Planning and Zoning Commission

Tuesday, October 4, 2022

Agenda Title: Discuss and consider action on Architectural Pre-Approval for the Glenn and Venue buildings of the Backyard project located at 13801 Bee Cave Parkway, Bee Cave, TX 78738

Subject: **Backyard – Glenn and Venue Architectural Pre-Approval** - *COBC Staff comments round 3 (final)*

3 G1 - ELEVATION C
SCALE: 1/8" = 1'-0"

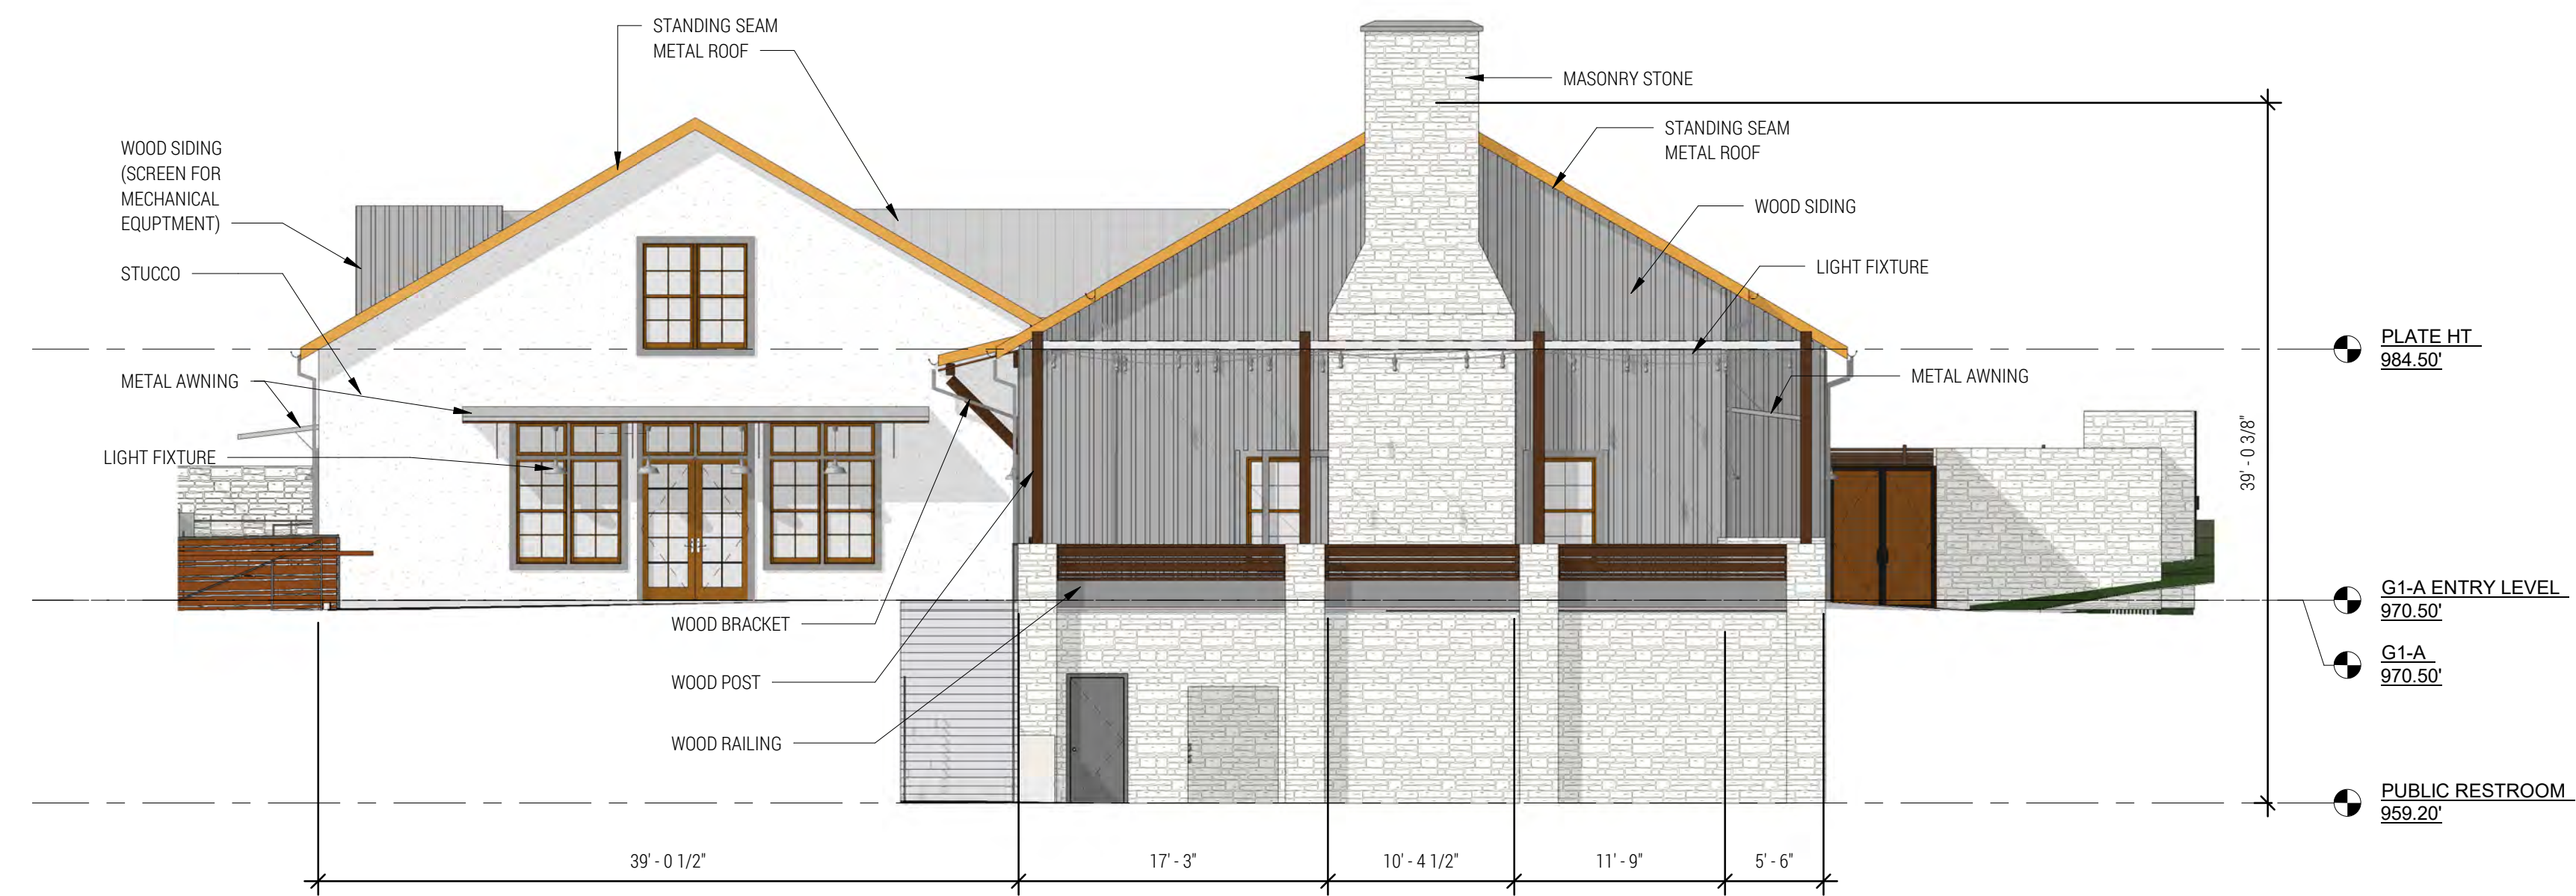
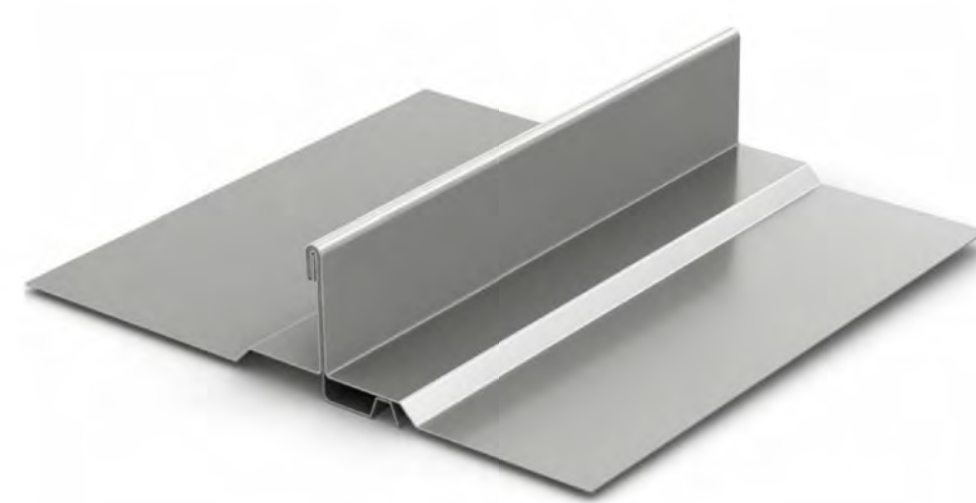
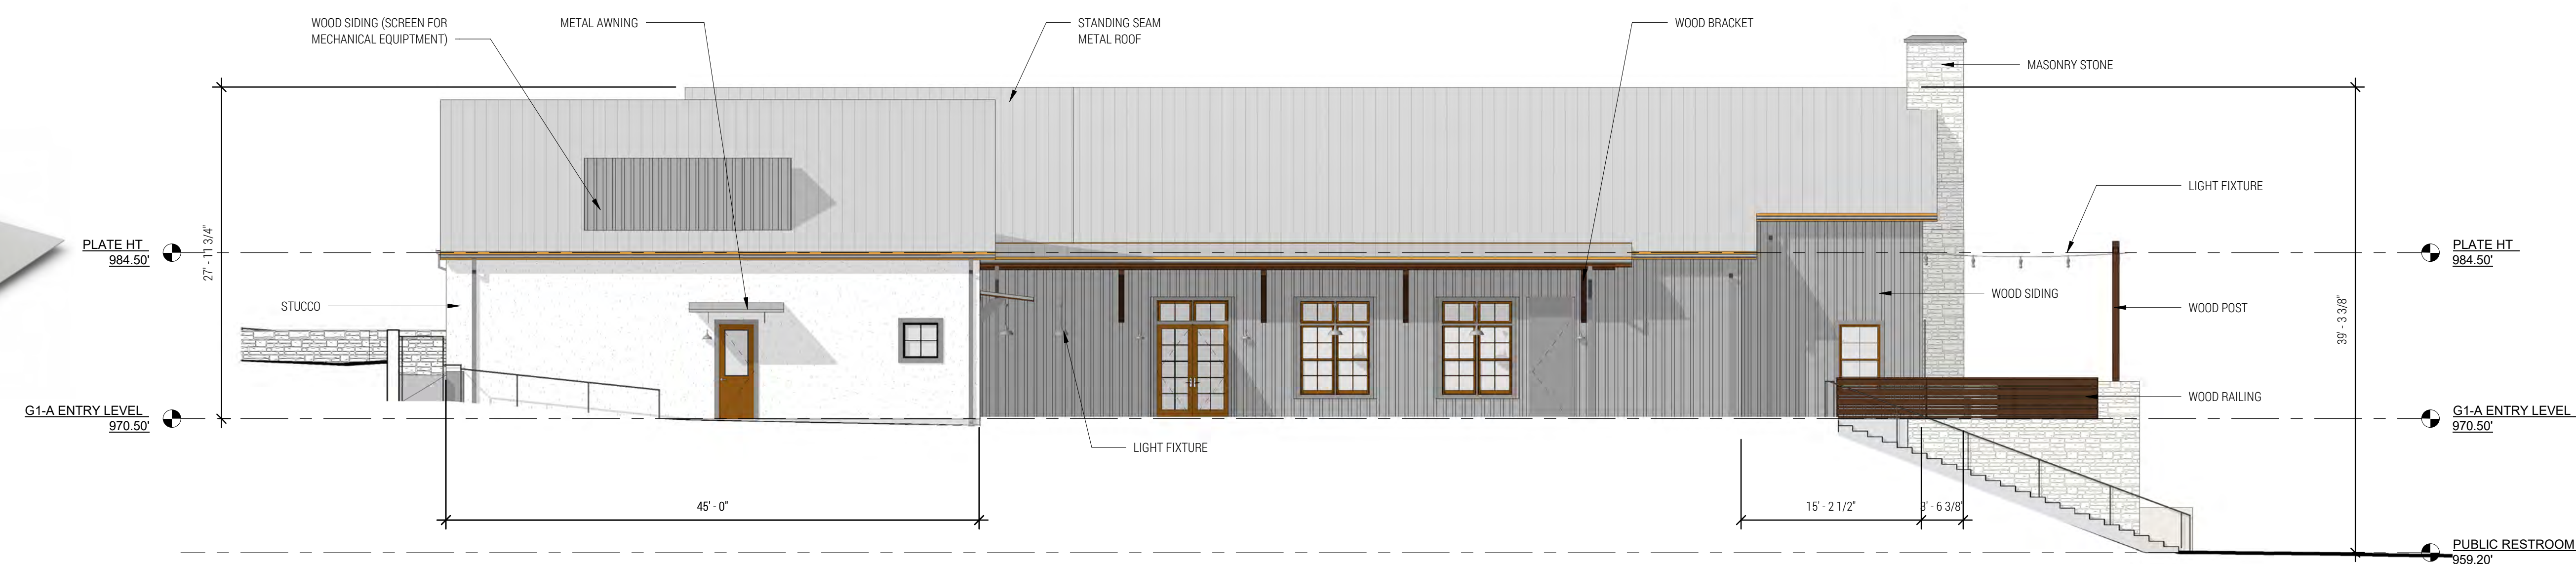
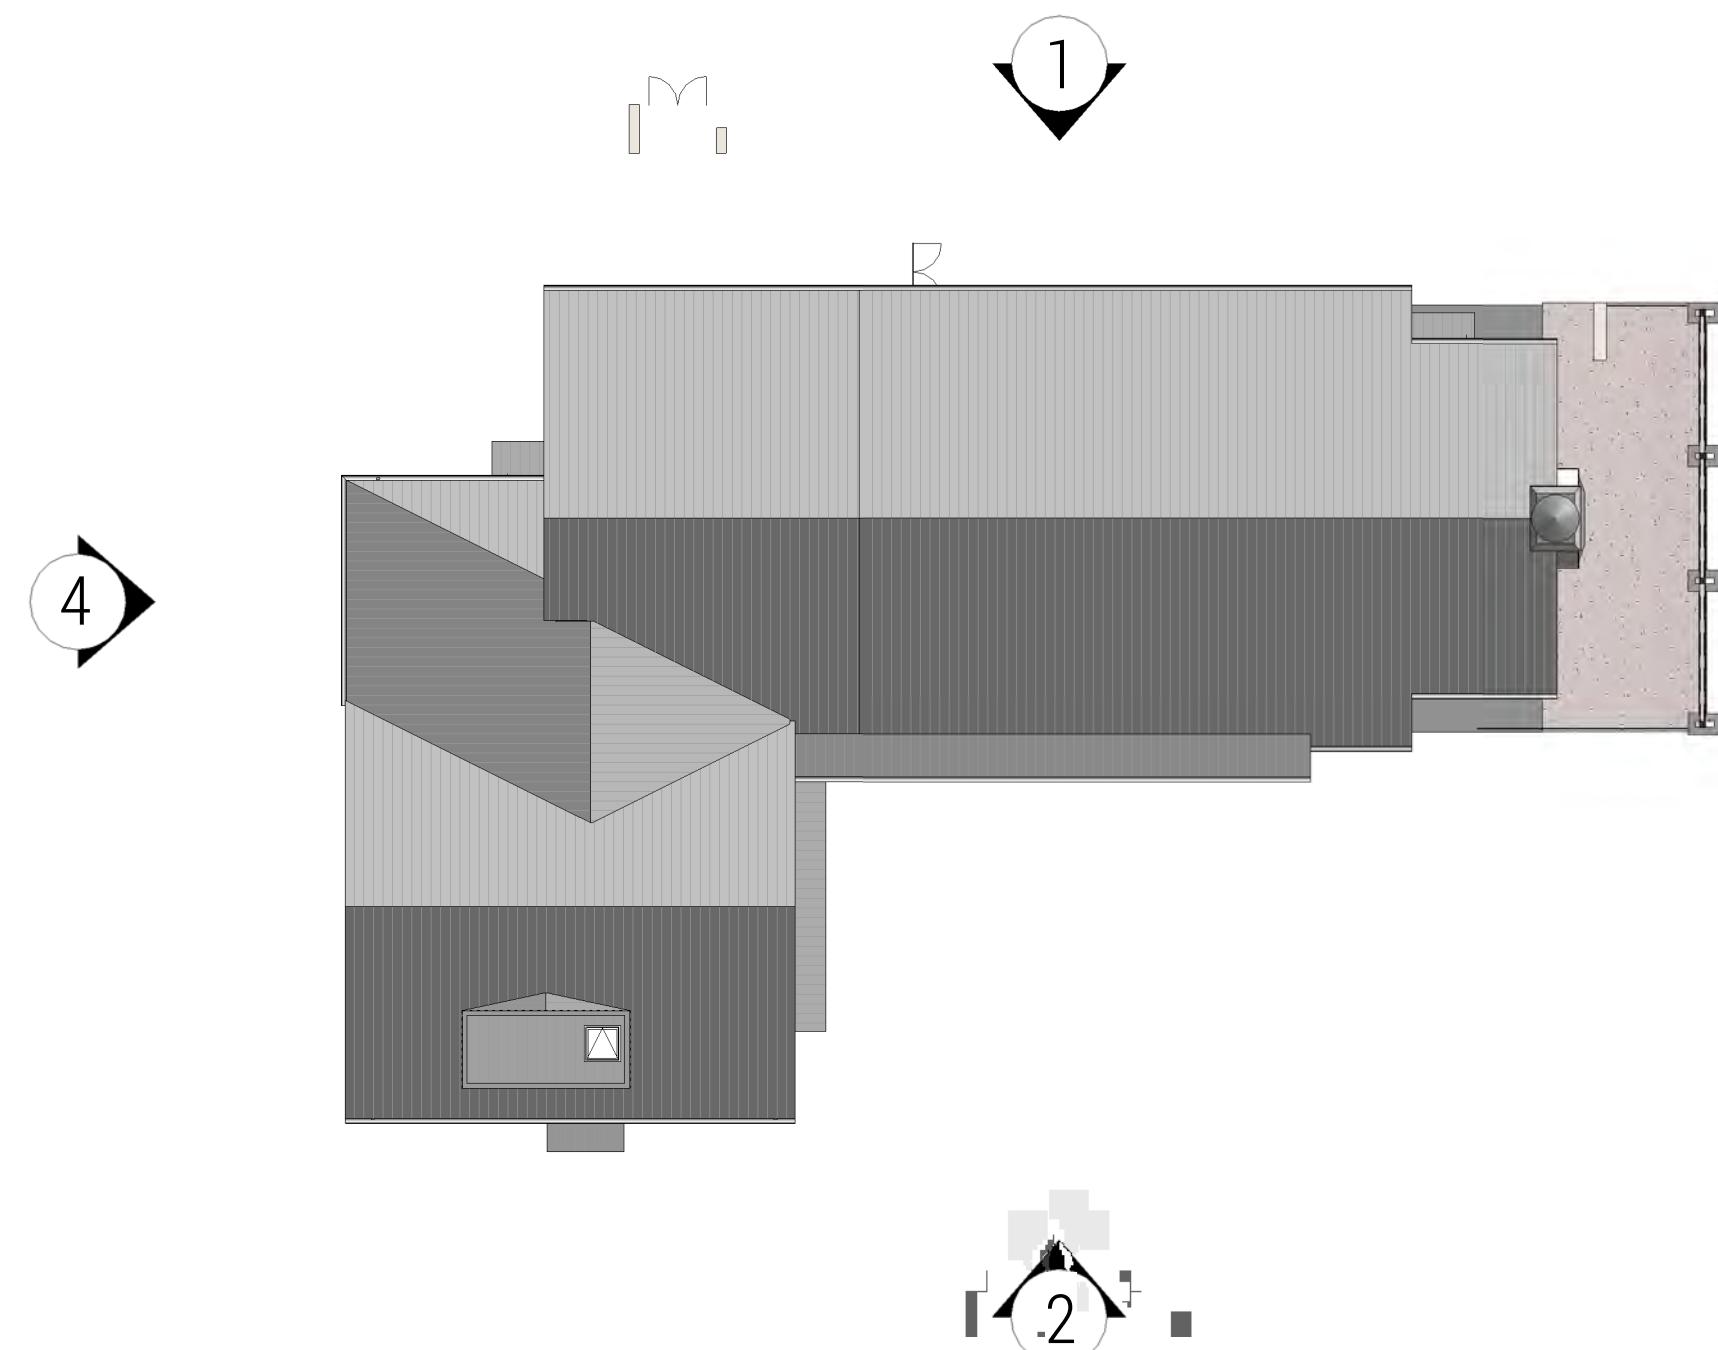
Building #		Use(s)		Gross Area (SF) Allowed		Gross Area (SF) Actual		Bldg. Footprint (SF) Allowed		Bldg. Footprint (SF) Actual		# Levels		Building Height (from low grade) allowed		Building Height (from low grade) actual		Height - includes parapets, mechanical equipment, elevator housing or other structural component		Buildings are 1 to 2 stories		Scale and architectural elements of the buildings are to be sympathetic to historically inspired Hill Country vernacular architecture...		Max. Building GFA of 12,500 SF		Buildings terrace into natural grade to provide an integrated, accessible pedestrian connectivity		Buildings incorporate a variety of outdoor spaces to include porches, courtyards, plazas, decks, and park-like areas		Buildings treat Willie Way & Amp Rd. as public roads		Buildings meet Variation standards 33% & 5 changes for front/facades facing public roadway - 25% & 3 changes for others		Building meets Horizontal Articulation standards Max 50ft. Wall plane module / vertical element		Building meets Vertical Articulation standards Varying roof lines; max 60' roof run w/o height transition		Materials - limestone, rustic wood, stucco, brick, concrete, or other stone		Materials - Max. 50% glazing per wall, max 30' horizontal with min. 3" break		Materials - Max. 10% metal		Notes / Other comments COBC 1.22		DESIGN TEAM 6.22 RESPONSE		COBC 8/22 Response		DESIGN TEAM 9.9. RESPONSE		COBC 9/22 Response

PDD Ord. 428 Development Standard Reference																		Ex. C. - IV.B.		Ex. C - III.B.2		Ex. C - III.B.3		Ex. C - III.B.3		Ex. C - III.B.4		Ex. C - III.B.5		Ex. C. - IV.A.1		Ex. C. - IV.A.3		Ex. C. - IV.A.3		Ex. C. - IV.A.3		Ex. C. - IV.A.3.b.		Ex. C. - IV.A.3.a.		Ex. C. - IV.A.3.c.									
G9	Brew House	11,300	10,260	5,200	5,130	2	42'-0"	40'-3"	Yes	2	Yes		Yes			Large beer garden on S. side of Bldg.	Public roadway facades: C - Willie Way	D - Yes C - Yes B - Yes A - Yes	D - Yes C - Yes B - Yes A - Yes	D - Yes C - Yes B - Yes A - Yes	D - Yes C - Yes B - Yes A - Yes	D - Yes C - Yes B - Yes A - Yes	N/A metal not used as façade material			"ENTRY AREA WILL NOT PROVIDE SEATING, BUT THERE IS A LARGE BEER GARDEN/SEATING AREA ON SOUTH SIDE OF BUILDING ~COMPLIANCE ELEMENTS HAVE BEEN CLARIFIED ON PLANS.	Comments cleared/no further comments.																										
G10	Wine Bar/Retail/Events	10,500	9,478	5,600	4,739	2	34'-0"	34'-0"	Yes	2	Yes		Yes			Porches/outdoor gathering area (2nd floor deck)	Public roadway facades: No, shielded by bldg. G9	D - Yes C - Yes B (front) - Yes A - Yes	D - Yes C - Yes B - Yes A - Yes	D - Yes C - Yes B - Yes A - Yes	D - Yes C - Yes B - Yes A - Yes	D - Yes C - Yes B - Yes A - Yes	N/A metal not used as façade material			No additional comments.
